**RE: Proposed Redline Change to Proposed Road Improvements at Renwick Way
Acton Planning Board Decision 06-06**

**SKETCH PLAN OF PROPOSED
 REVISED SU-30 TURNAROUND**

LOCATION:
RENWICK WAY - 45 MAIN STREET
 ACTON, MASSACHUSETTS

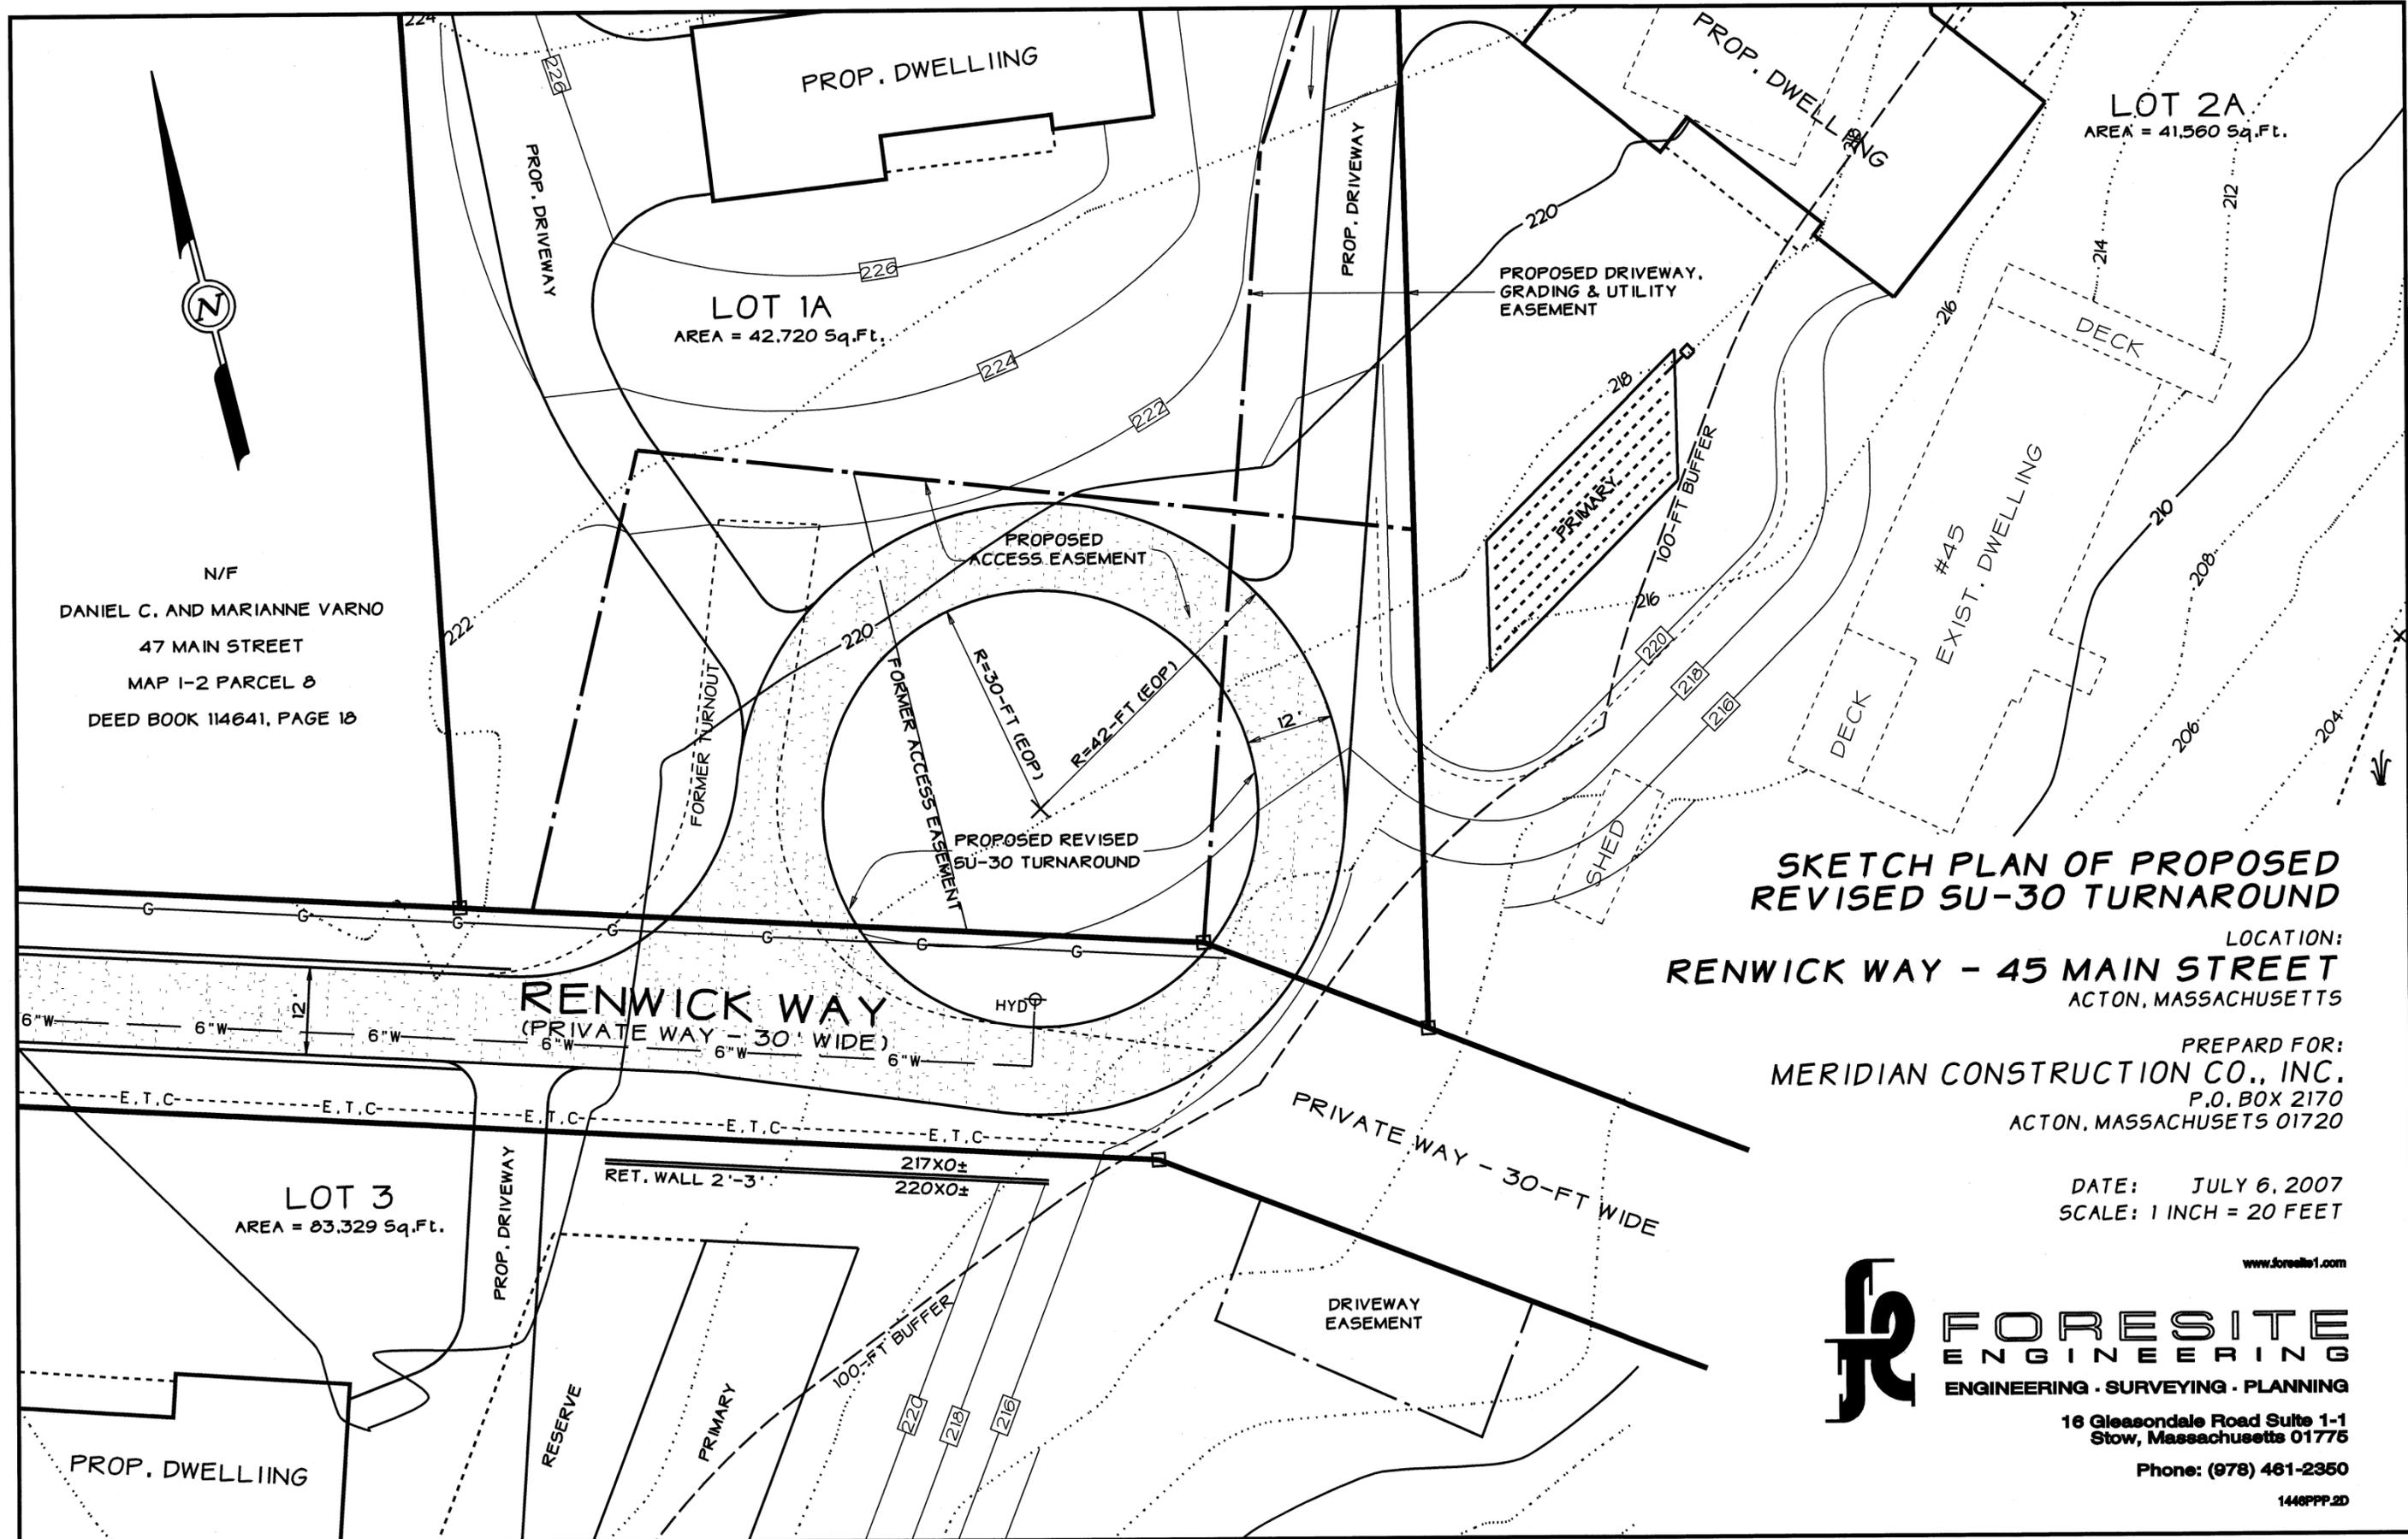
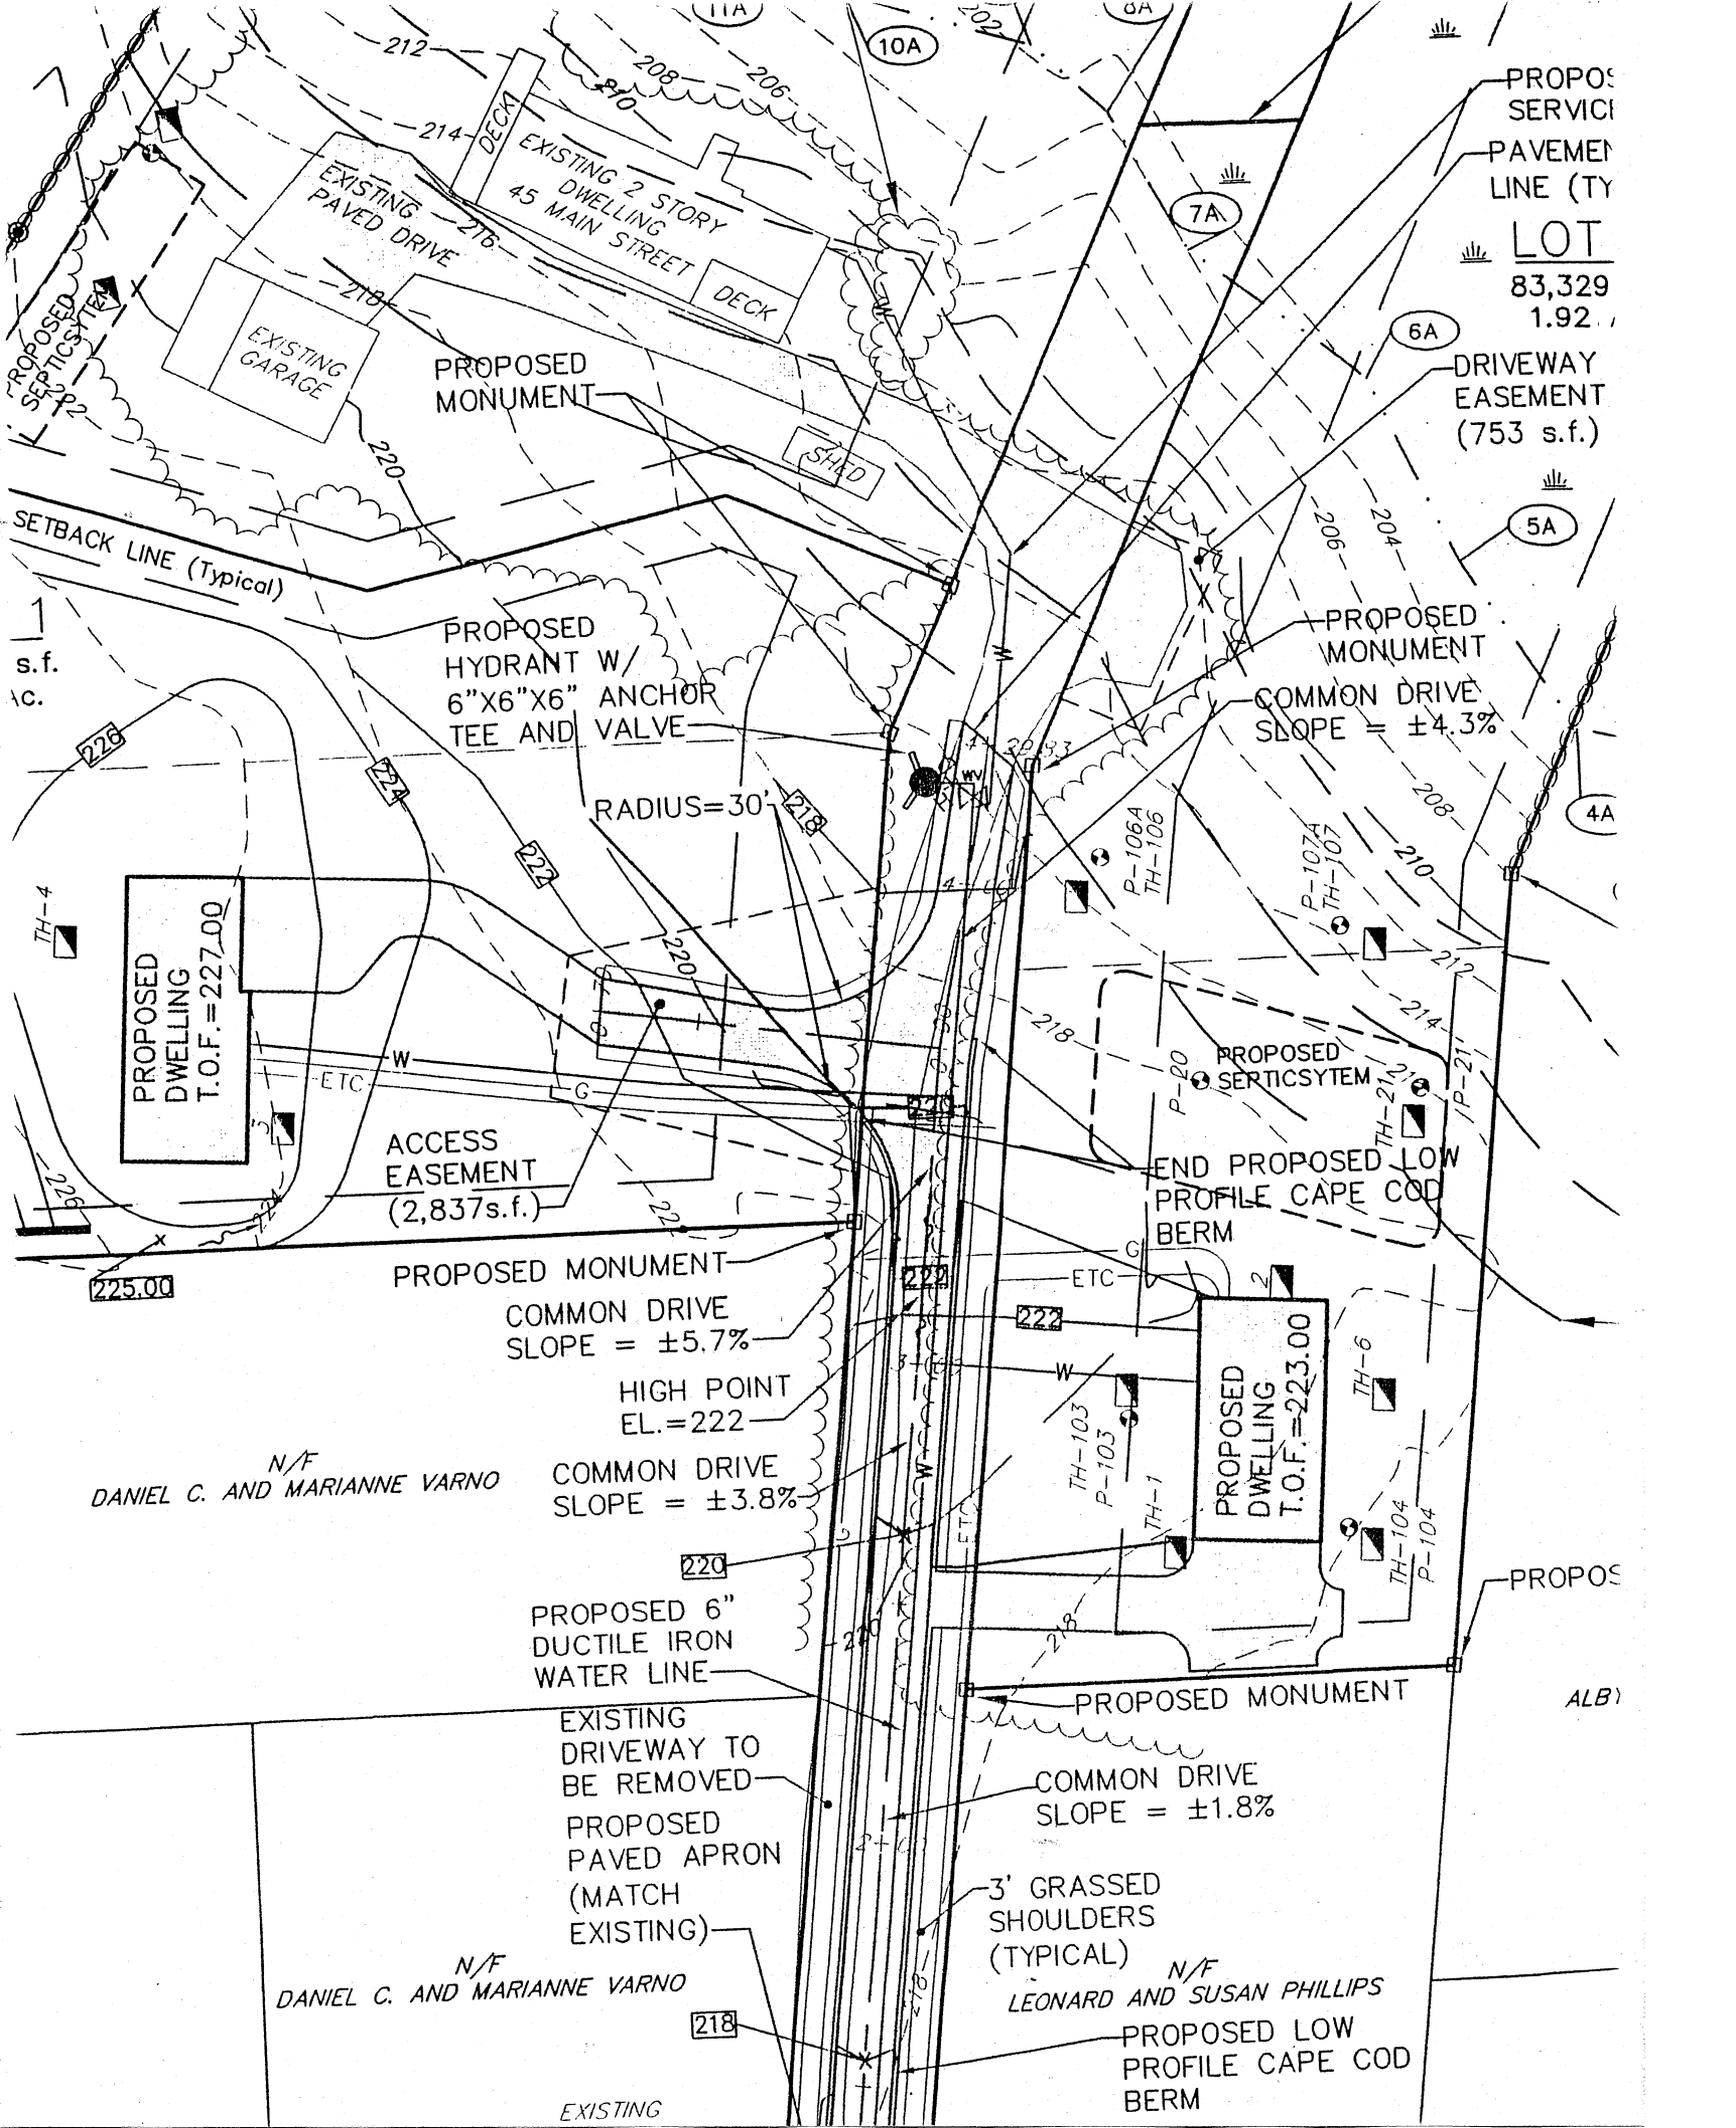
On behalf of our client, Meridian Construction Company, Inc., we respectfully request the Planning Board to accept the attached plan entitled "Sketch Plan of Proposed Revised SU-30 Turnaround" prepared by FORESITE Engineering Associates, Inc. dated July 6, 2007, Scale 1"=20', as a redline change to the proposed "Road Improvement Plan, Main Street, Acton Massachusetts" prepared by Landtech Consultants, Inc., most recently revised, for proposed road improvements at 45 Main Street (Renwick Way).

The proposed SU-30 turnaround on the approved Road Improvement Plan (copy attached) is a "T" type turnaround. Our client, the buyer of the property, has expressed concern over the aesthetic of this design and requested that we modify it so as to be a full circle, cul-de-sac type turnaround instead of a "T". The proposed modification would provide adequate turning radii for an SU-30 design vehicle without the need to reverse to complete the maneuver.
